EXPERT WITNESS REPORT

8 Example Street
Googong, NSW 2620

Client Name
JULY 19, 2024

INSUFFICIENT ALFRESCO AND VERANDAH SUPPORT - NON-COMPLIANCE WITH APPROVED PLANS

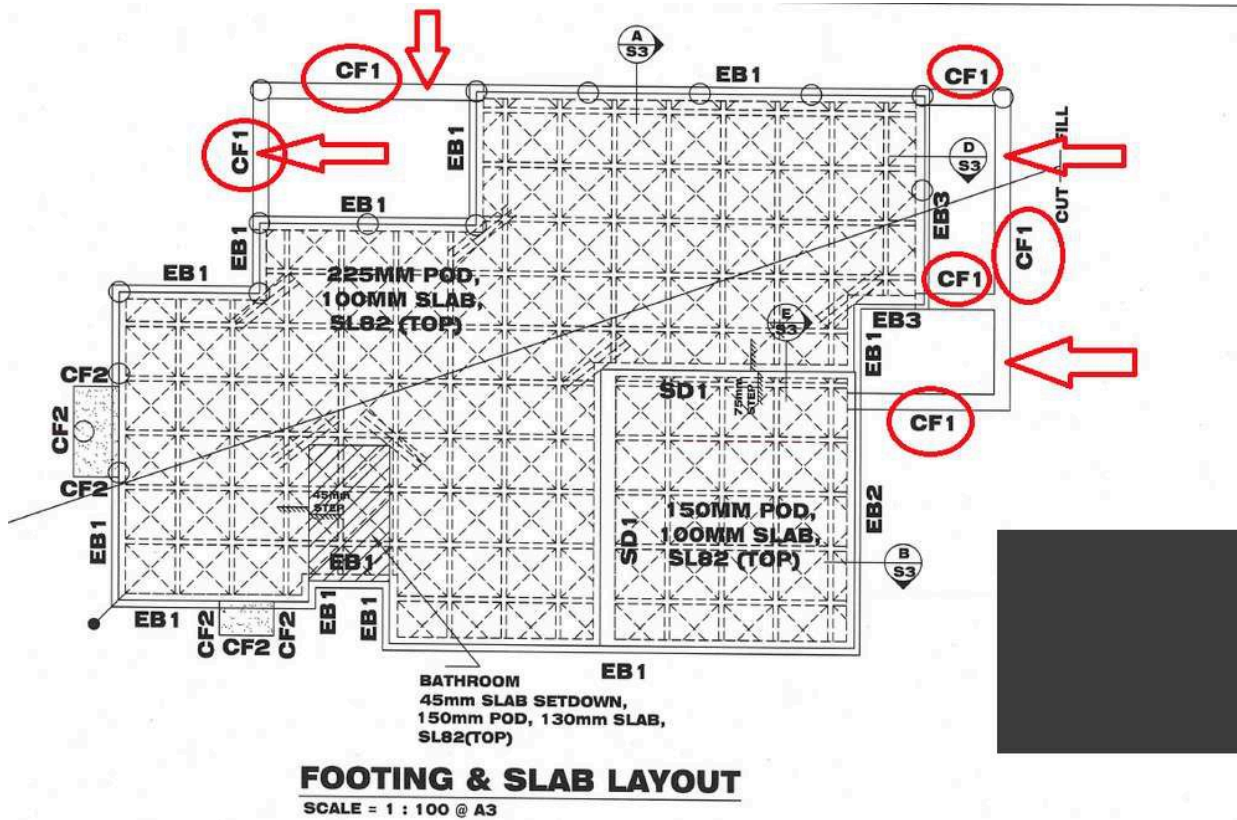
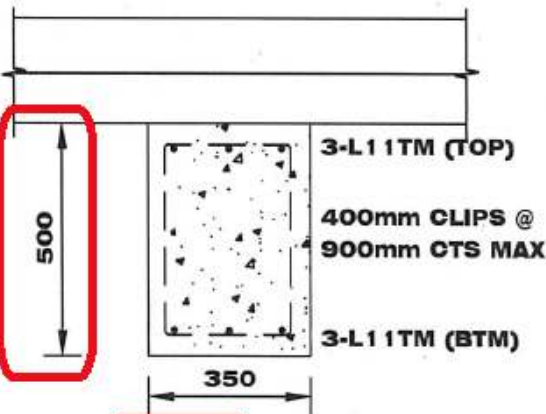
- A 600mm horizontal gap and 100mm vertical gap exist here. This section also shows poor connection between the surface concrete and the edge beam.

- A 300mm horizontal gap and 50mm vertical gap have been noted. Although smaller than other areas, this still presents a structural deficiency.

+ MISSING - NOT MATCHED WITH PLANS

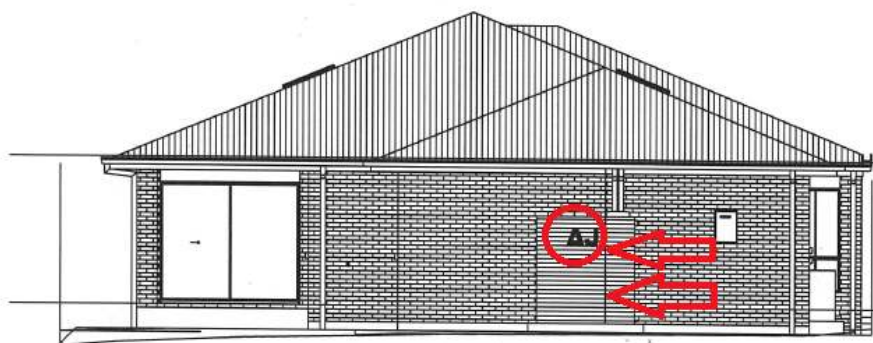
Defect: The articulation joint specified on the plans at the rear of the building (where the water tank is located) has not been constructed.

By not constructing the articulation joint as specified, the builder has not complied with the documented plans and the relevant Australian Standards, which are integral to these references. This omission should be addressed promptly to prevent future structural issues.

+ CLEARANCE LESS THAN 150MM (OR 75MM FOR GRADED SITES)

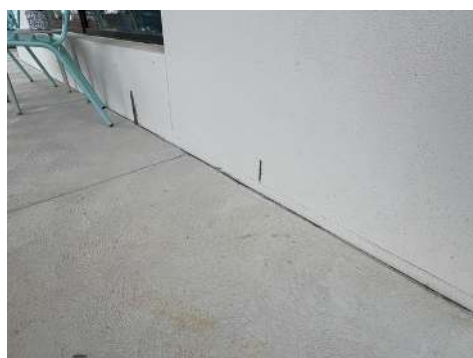
Defect: The bottom of the weep holes is not positioned at the required minimum height of 150mm (or 75mm for graded sites) above the adjacent surface level. Rectification is required to meet this standard.

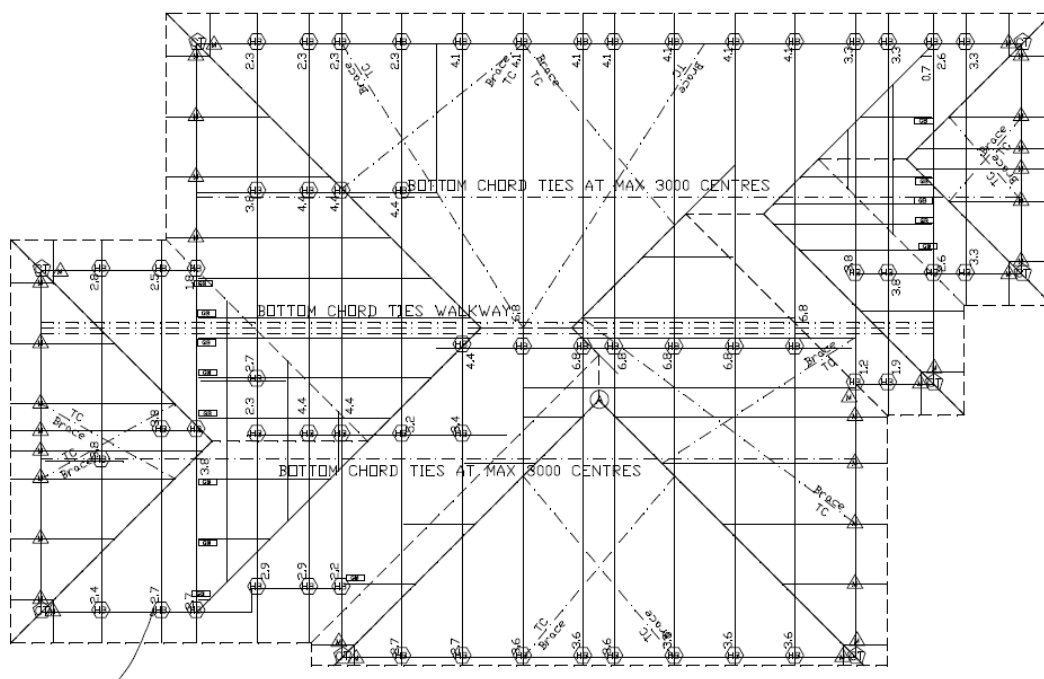
Cutting these bracings will directly compromise the structural integrity of the roof, as the bracing system is designed to provide lateral stability and prevent deformation or collapse during wind or other external forces. Without proper bracing, the roof may become susceptible to:

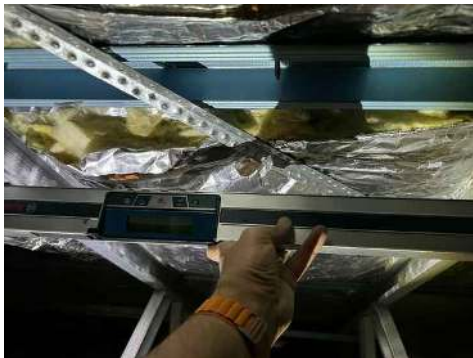
Sarking has been observed sagging by over 65-100mm, which exceeds the allowable limit of 40mm. Sarking is designed to provide a protective layer that directs moisture away from the roof space, preventing water damage. When the sarking sags beyond its allowance, it creates low points where water can collect, also known as water ponding.

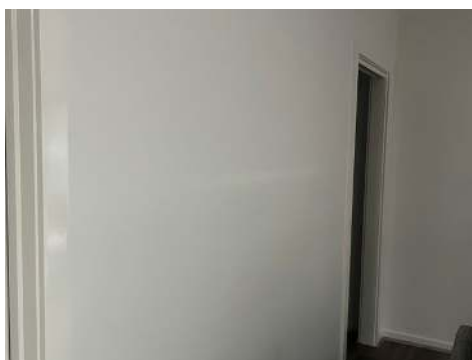
The paintwork quality throughout the dwelling is substandard.

Plaster joint lines are visibly noticeable from a distance of 1.5 metres, indicating improper surface preparation or finishing. Additionally, poor architrave joints and other defective areas of paintwork have been observed, further diminishing the overall finish quality. Rectification is required to ensure that all surfaces, joints, and finishes meet acceptable standards for a professional appearance.
